PIC12C508/509

PIC12C508/509 Data Sheet Errata

The PIC12C5XX parts conform functionally to the PIC12C5XX Data Sheet (DS40139E), except for the anomalies described below:

CLKIN/CLKOUT PIN STATES WHEN MCLR ASSERTED

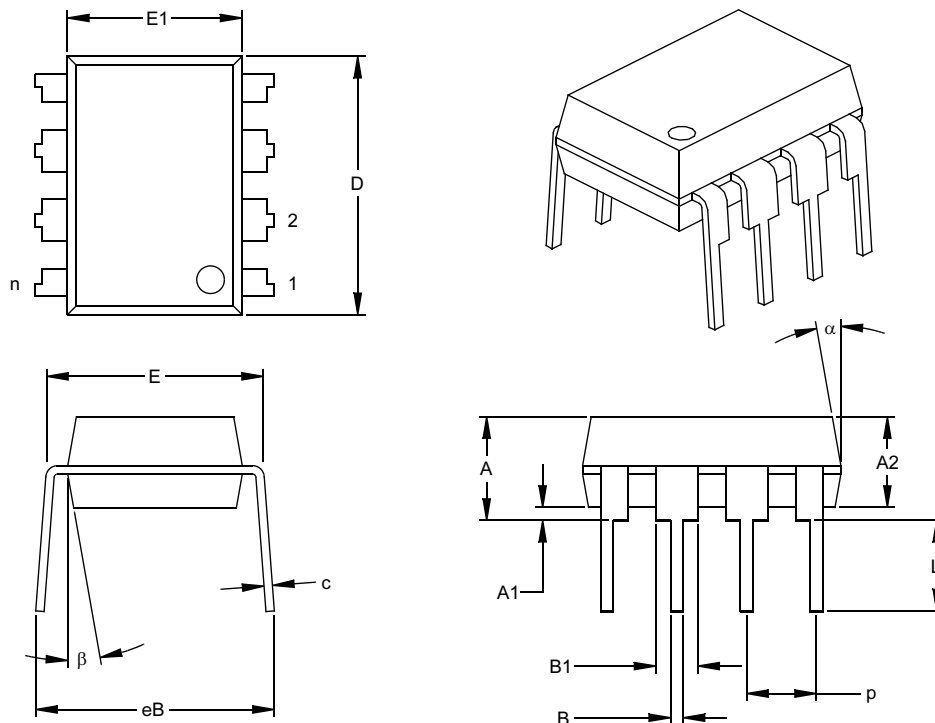
1. Module: RESET

When MCLR is asserted, the state of the OSC1/CLKIN and CLKOUT/OSC2 pins are as follows:

Oscillator Mode	OSC1/CLKIN Pin	OSC2/CLKOUT Pin
EXTRC, CLKOUT on OSC2	OSC1 pin is tristated and driven by external circuit	OSC2 pin is driven low
EXTRC, OSC2 is I/O	OSC1 pin is tristated and driven by external circuit	OSC2 pin is tristate input
INTRC, CLKOUT on OSC2	OSC1 pin is tristate input	OSC2 pin is driven low
INTRC, OSC2 is I/O	OSC1 pin is tristate input	OSC2 pin is tristate input

8-Lead Plastic Dual In-line (P) – 300 mil (PDIP)

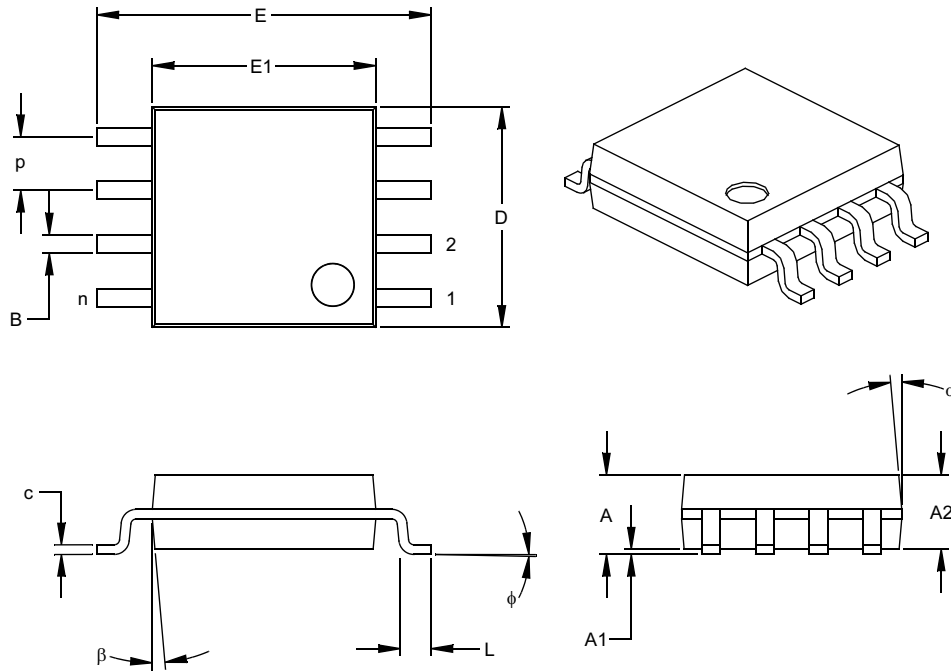
2. Module: Packaging

The package information contained in the data sheet is incorrect. Please refer to the following tables for correct package data.

Units		INCHES*			MILLIMETERS		
Dimension Limits		MIN	NOM	MAX	MIN	NOM	MAX
Number of Pins	n		8			8	
Pitch	p		.100			2.54	
Top to Seating Plane	A	.140	.155	.170	3.56	3.94	4.32
Molded Package Thickness	A2	.115	.130	.145	2.92	3.30	3.68
Base to Seating Plane	A1	.015			0.38		
Shoulder to Shoulder Width	E	.300	.313	.325	7.62	7.94	8.26
Molded Package Width	E1	.240	.250	.260	6.10	6.35	6.60
Overall Length	D	.360	.373	.385	9.14	9.46	9.78
Tip to Seating Plane	L	.125	.130	.135	3.18	3.30	3.43
Lead Thickness	c	.008	.012	.015	0.20	0.29	0.38
Upper Lead Width	B1	.045	.058	.070	1.14	1.46	1.78
Lower Lead Width	B	.014	.018	.022	0.36	0.46	0.56
Overall Row Spacing	§ eB	.310	.370	.430	7.87	9.40	10.92
Mold Draft Angle Top	α	5	10	15	5	10	15
Mold Draft Angle Bottom	β	5	10	15	5	10	15

Dimensions D and E1 do not include mold flash or protrusions. Mold flash or protrusions shall not exceed

.010" (0.254mm) per side.
